MEMORANDUM

RE: LU 2021-006 SP / VAR Sherwood Blvd. Multifamily

Date: July 19, 2022

Figure 2: Green Spire Euonymus at 5-gallon container size, available at www.brickee.com

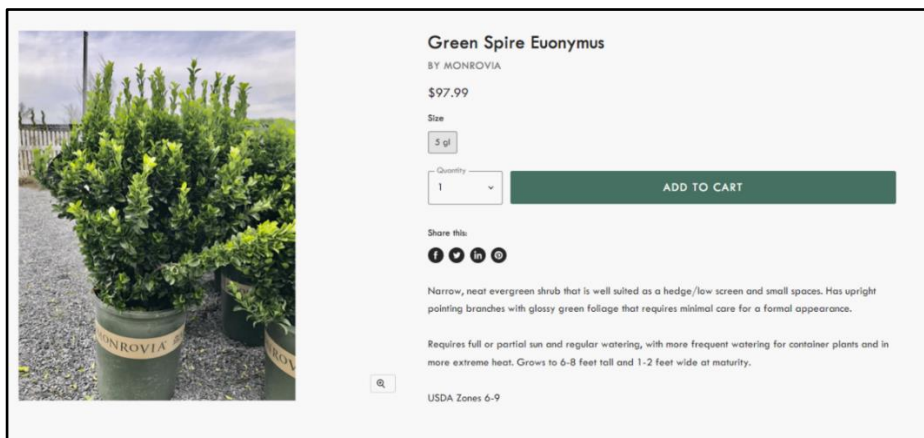
Public testimony was received regarding the poor condition of the existing fence along the shared property line and the potential impact of new vehicles and people on the site to the existing residents of Stewart Terrace. The applicant has requested a variance in this location to reduce the landscaping buffer between the parking area and the property line from 10 ft. to 2 ft.

The applicant is also proposing to install Green Spire Euonymus shrubs from 3-gallon containers along the property line between the curb and the new fence. Green Spire Euonymus is considered a fast growing shrub that reaches a mature height of 6 – 8 ft. Readily available container sizes range from 1 – 3 gallons, however, 5-gallon containers also appear available online. Staff recommends requiring the new plantings at the 5-gallon container size in order for the hedge to reach maturity and provide the desired buffer on a shorter timeframe.

The applicant has agreed to install a new 6 ft. tall vinyl fence along the shared property line to replace the existing wooden fence and provide a solid and continuous screen between the properties. As discussed during the hearing, the applicant is prohibited from installing anything taller than a 6 ft. tall fence based on current City code.
